Date: January 15, 2008

Subject: Request for additional information regarding FCC ID: IHDT56GM2

Correspondence Reference Number: IHD7633
Confirmation Number: 707120633-35
Date of Original Email: December 26, 2007

Peak Output Power

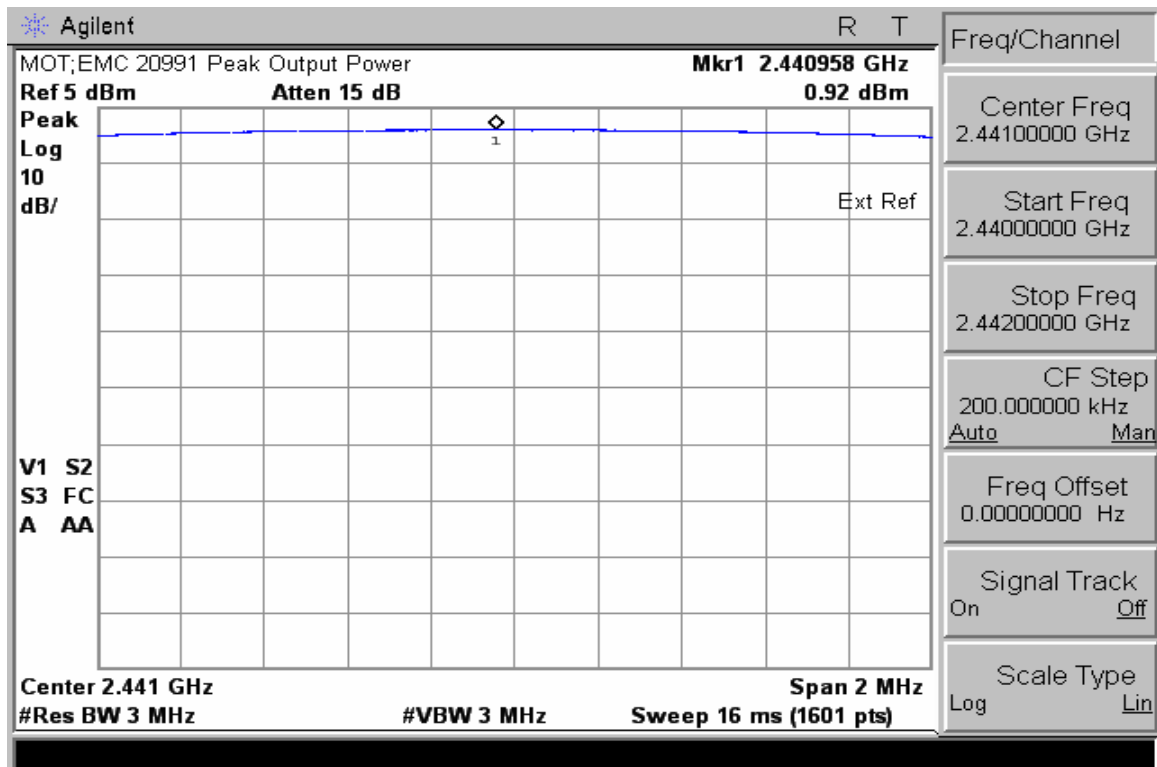
- The Bluetooth conducted output power measurement was performed with a RBW = 1 MHz. Please remeasure the conducted output power with a RBW that is greater than the 20 dBc bandwidth of the emission and submit that data.

Response: Please refer to the following replacement graph.
